## AGENCY COMMENT REQUEST

**SUBJECT:** **SUBDIVISION MS18-0008**  
**STAFF REPORT & CONDITIONS OF APPROVAL**  
(Freitas/Norris Canyon Rd./San Ramon/APN 211-210-029 & 075)

**Subject: Geologic Peer Review – MS18-0008**  
Robert Freitas (owner & applicant)  
APN 211-210-029 & -075 / 2350 Norris Cyn. Rd.  
San Ramon Area, Contra Costa County  
DMA Project # 3033.18

**RE: PLANNING APPLICATION REVIEW AT**  
**2350 Norris Canyon RD**  
**Contra Costa Cty, CA 94583**  
**APN: 211210075**

**Figure 2: MS18-0008 USGS Geologic Map**

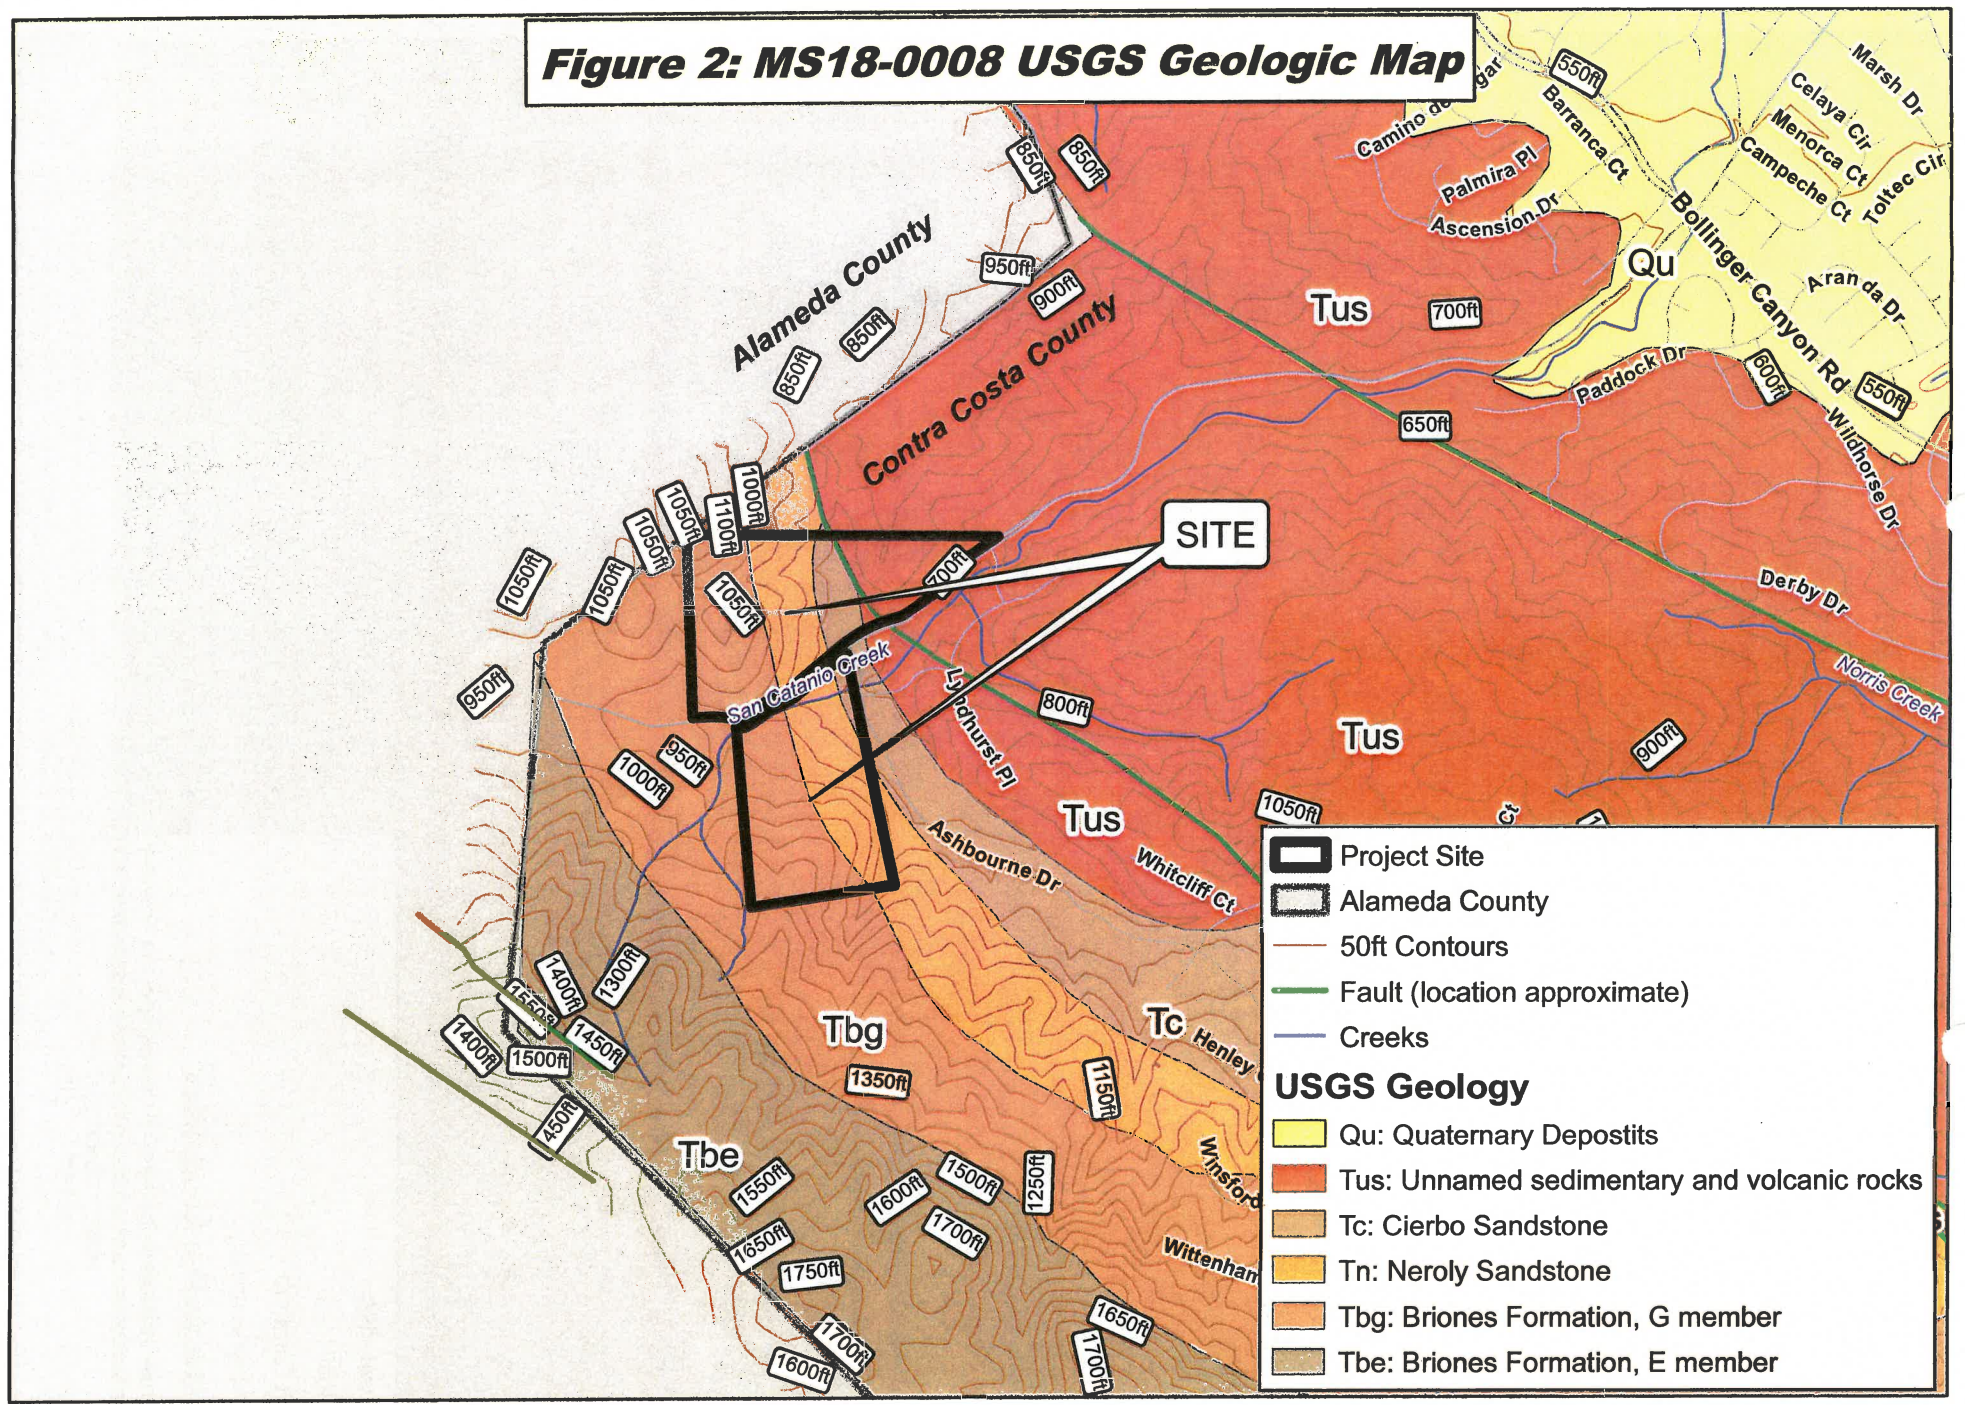
In 1994 the U.S. Geological Survey (USGS) issued a color, digitized bedrock geology map of Contra Costa County.<sup>5</sup> This map, which was based on compilation of previous published mapping, is presented in Figure 2. The boundary of the two existing parcels that make up the MS18-0008 project site are identified with a heavy black line. According to this map the site is in the outcrop belt of sedimentary rocks, including Unnamed sedimentary and volcanic rocks of Pliocene age (Tus), along with three formations of Miocene age: Cierbo Sandstone (Tc), Briones Formation (Tbr) and Briones Formation, G-Member (Tbg). With regard to geologic structure, the rocks on site are tightly folded. Bedding strikes approximately north-south, and dips to the east. Based on interpolation from nearby measurement, the dip of bedding is inferred to range from 45 to 60°. Although no active faults bisect the site, Figure 2 shows an inactive fault crossing the easternmost portion of the property. Even inactive faults may present foundation problems associated with the contrasting properties on bedrock on opposite sides of the shear zone, along with the adverse engineering properties of the fractured and sheared rock in the fault zone.

In summary there are two basic rock types on the property. The eastern ¼ of the northernmost parcel is within the outcrop belt of Tus. This is chiefly a non-marine formation of Pliocene age. It is weakly consolidated, clayey and prone to shallow to intermediate depth landslides and slope creep. The remainder of the site is underlain by marine sedimentary rocks (chiefly sandstone) of Miocene age. In general the Miocene age formations (Tc, Tbr and Tbg) present good foundation conditions. However, the adjacent Norris Canyon Estates project had on the order of fifty landslides, several of which were deep seated. Considerable remedial work was performed to create stable building pads. The rough grading for that project took three grading seasons. In summary, the Miocene bedrock typically consists of alternating beds of dense hard sandstone, with interbedded weak rock (mudstone, siltstone and soft, clayey

**Figure 3: MS18-0008 Landslide Map**

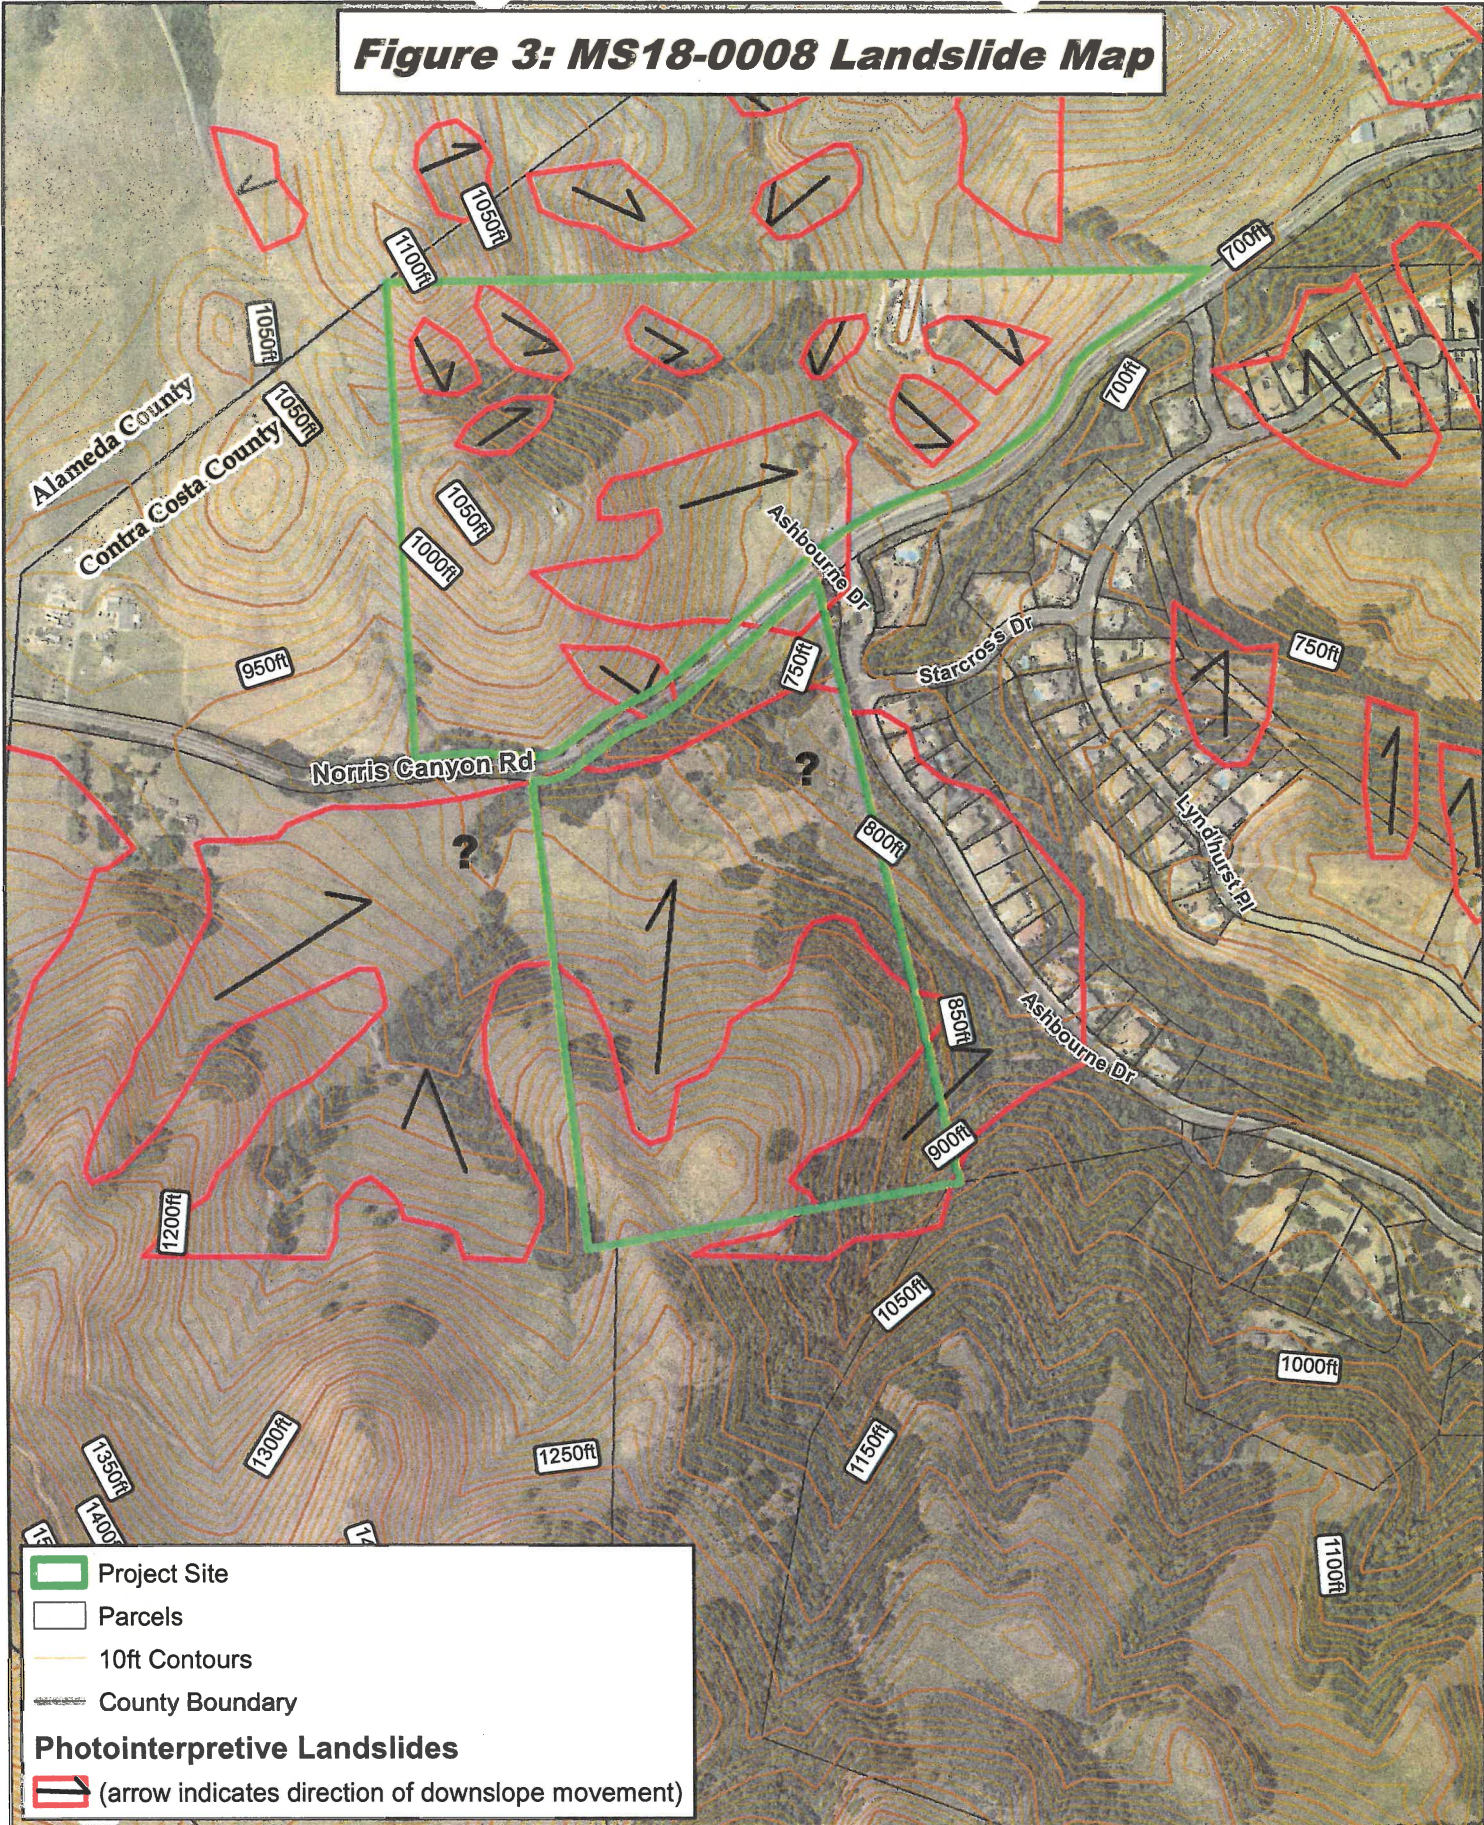
In 1975 the U.S. Geological Survey issued photo-interpretation maps of landslide and other surficial deposits of Contra Costa County. (That mapping is presented on Page 10-24 of the Safety Element of the County General Plan.) To enhance readability the USGS landslide map of the site and surrounding area has been enlarged to a scale of 1 in.= 500 ft. and transferred to a base map that is an aerial photograph that shows topography (10 ft. contours), creeks (represented with a blue line), the local road network, and the Alameda/ Contra Costa County line (see Figure 3).<sup>9</sup> The boundary of the two parcels that make up the site is indicated with a green line. A large landslide complex is indicated on the southern-most parcel that is queried in area of the toe-of-slide, indicating geomorphic evidence of the toe is not well defined. (Typically landslides are most clearly defined in the scarp area, but in the case of dormant slides, the toe and lateral margins are less well defined.) Nine (9) smaller landslides are delineated on the northernmost parcel. The density of slides on this parcel can be considered the site is marginally stable, and likely to be sensitive to grading and development. Note that landslides daylight at/near the Norris Canyon Rd. right-of-way. The activities of man of the northern parcel could risk reactivation of those slides.

It should be recognized that the landslides shown in Figure 3 were mapped by an experienced USGS geologist who relied solely on geologic interpretation of stereo pairs of aerial photographs, without the benefit of a site visit or any subsurface data. Furthermore, landslides mapped by the USGS are not classified on the basis of the (i) activity status (i.e. active or dormant), (ii) depth of slide plane (shallow or deep seated), or (iii) type of landslide deposit. Additionally the map was based chiefly on geologic interpretation of photographs from the 1960s and early 1970s. Consequently, it does not show landslides that have occurred within the last 50 years±. Nevertheless, the map fulfills its function, which is to *red flag* sites that may be at risk of landslide damage, where detailed geologic and geotechnical investigations are required to evaluate risks and develop measures to reduce risks to a practical minimum.

- Submit a revised TPM that includes topography, and which shows landslides and other hazardous areas of the site (e.g. existing fills, areas exhibiting an excessive rate of erosion, over-steepened creek banks, etc.), and provide a slope map of the property.
